**Re: Zoning By-law Amendment ZBA 01/16 (D14 TO)
Draft Plan of Subdivision D12 23T-16001
Bonnarrow Meadows – Rockwood
Project No.: 300035946.0000**

We have reviewed the above noted application along with the following documentation:

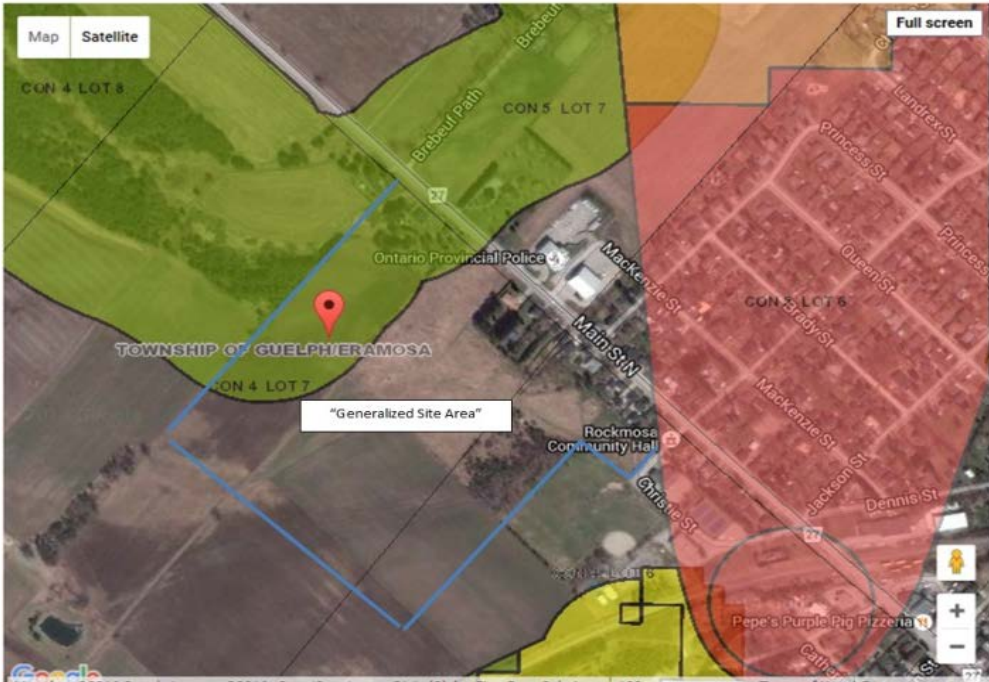
1.13		<p>As shown in green, a portion of the property is located within an Intake Protection Zone (IPZ) and the site is located less than 300 m from the Station Street Rockwood Wells 1 and 2.</p>  <p>Although the site is not specifically located within a well head protection area (WHPA), a Source Water Impact Assessment and Management Plan should be completed to evaluate (and mitigate) negative effects on recharge from fill importation on to the Site and the use of road salt and landscape fertilizers / pesticides.</p>
